## **Attachment A – Response to Referral Agencies**

**February 2026**

The following provides a full response to the referral agencies responses to the proposed development

<p>3 PAD SITE 1 - NORTH ELEVATION 2.11 1:200</p>	 <p>AHD 0.489 m</p>
<p>Elevation of Service Station and active frontage to new Link Rd</p>	<p>Entries, pedestrian paths, carparking and landscaping to new Link Rd to activate the streetscape</p>

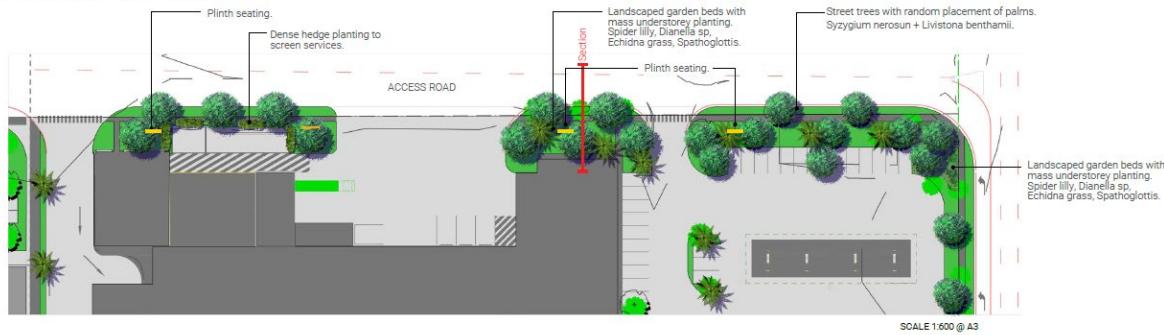
The request for updated Plans and Drawings covering a range of finer details with the design and layout for Stage 1 has been addressed. The updated Master Plan document and supporting plan set are contained in Attachment C1. The revised Subdivision plan set is contained in Attachment C2. C3 contains supporting plans which relate to the staging of associated works i.e. external road upgrades filling etc. C4 contains the updated architectural package and the landscape intent is within C5. Earthworks plans and associated reports are within C7. The plans relate to each other to enable the concurrent assessment and illustrate the orderly development of the site.

The Architectural Plans illustrate how the petrol station has been located to front the new link road, that part provided in Stage 1. This is to assist in activating/ fronting the new link road. This frontage is also activated through landscape works, new footpaths, internal carparking areas and the bowsers. The shop directly views the new link road.

The main commercial building has also been amended such that the sleaving retail tenancies adjacent to the new link road have glazing wrapping around the building and new entry from the link road frontage. This activates the new internal corner and also addresses the new link road. Pedestrian connections are established to internal paths and those on the new link road.

The main building has also incorporated new articulation and design features centrally within the built form and fronting the new link road. This includes in part an alternative façade treatment / architectural feature and new green wall treatments contributing both horizontal and vertical façade elements to the new link road. These treatments are to the facades relate to the screened loading dock area and staff carparking. Collectively the treatments to the built form, pedestrian interaction with built form also contributes to the main buildings' engagement with and activation to the new link road.

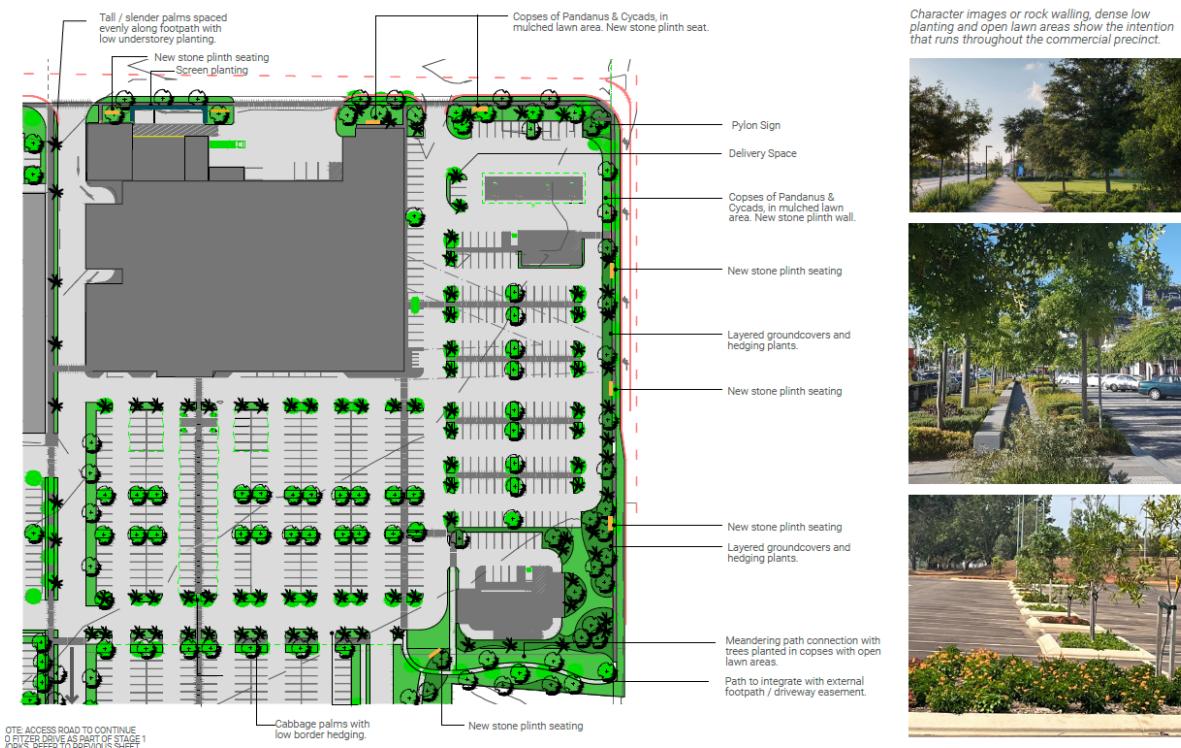
*Does not describe the subject land's current high levels of urban heat and its potential role in mitigating heat impacts through vegetation growth, infiltration of runoff and retention of soil moisture. Once developed, the current high levels of urban heat will be exacerbated and will affect both the land subject to development and adjacent land in the area.*

We note the existing SD37 planning control and Master Plan govern development of the site. The approvals envisage a commercial retail and industrial outcome for areas A and B. The Planning controls facilitate / 2007 scheme facilitates a large scale built form and requirements for carparking with this. We note the carparking requirements under the 2007 scheme and that of the current scheme do not contain seek to reduce carparking area as a measure to avoid urban heat

Not notwithstanding this envisaged development outcome, the proposal as illustrated in the SLI identifies the use of landscaped areas within the development footprint, shade trees/designated tree planting areas in carparking areas and shade structures to reduce the affect in the change in use and wide covered walkways (eaves) for the principal building. Additional built form construction methods will further address and mitigate heat. As illustrated below;
